Addendum 126 – Regulation No. 127

Revision 2 - Amendment 2

03 series of amendments to the Regulation – Date of entry into force: 4 January 2023

Uniform provisions concerning the approval of motor vehicles with regard to their pedestrian safety performance

Figure 5

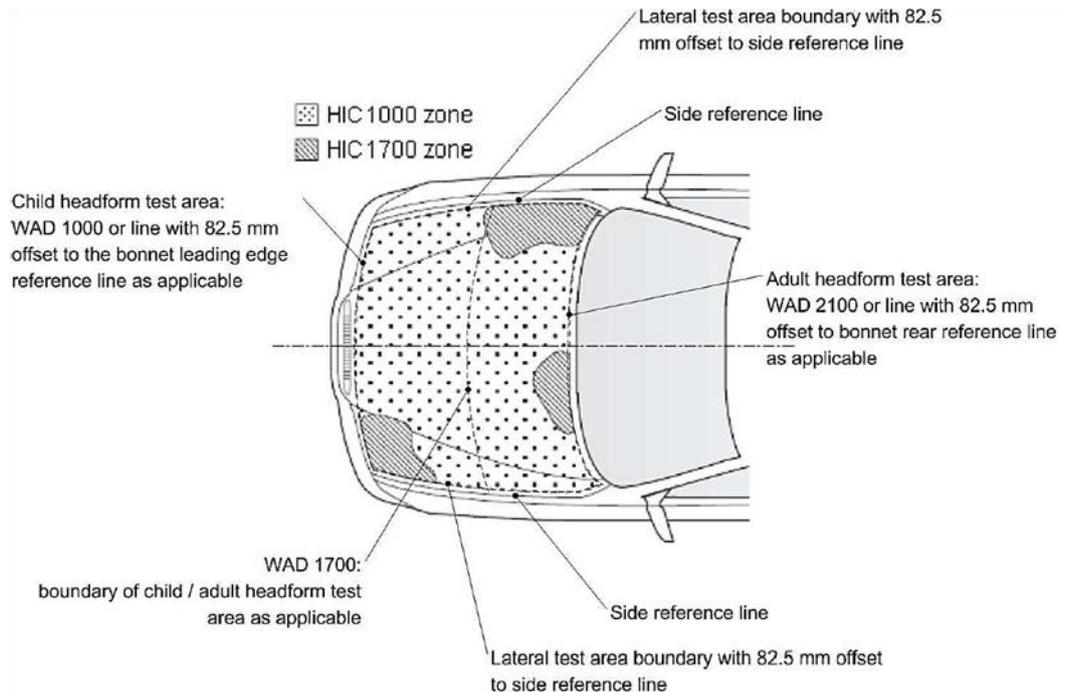
- "3.4.1. The manufacturer shall identify the zones of the bonnet top test area and of the windscreen test area where the HIC shall not exceed 1,000 (HIC1000 zone) or 1,700 (HIC1700 zone) (see Figure 5).

- 3.4.2. Marking of the "bonnet top" test area, marking of the windscreen test area as well as "HIC1000 zone" and "HIC1700 zone" will be based on a drawing supplied by the manufacturer, when viewed from a horizontal plane above the vehicle that is parallel to the vehicle horizontal zero plane. A sufficient number of x and y co-ordinates shall be supplied by the manufacturer to mark up the areas on the actual vehicle while considering the vehicle outer contour in the z direction. The cowl monitoring area is not considered for the marking of the "HIC1000 zone" and "HIC1700 zone".

- 3.4.3. The areas of "HIC1000 zone" and "HIC1700 zone" may consist of several parts, with the number of these parts not being limited. The determination of the impacted zone is done by the measuring point.

- 3.4.4. The calculation of the surface of the bonnet top test area and the calculation of the surface of the windscreen test area as well as the surface areas of "HIC1000 zone" and "HIC1700 zone" shall be done on the basis of a projected bonnet and windscreen when viewed from a horizontal plane parallel to the horizontal zero plane above the vehicle, on the basis of the drawing data supplied by the manufacturer."
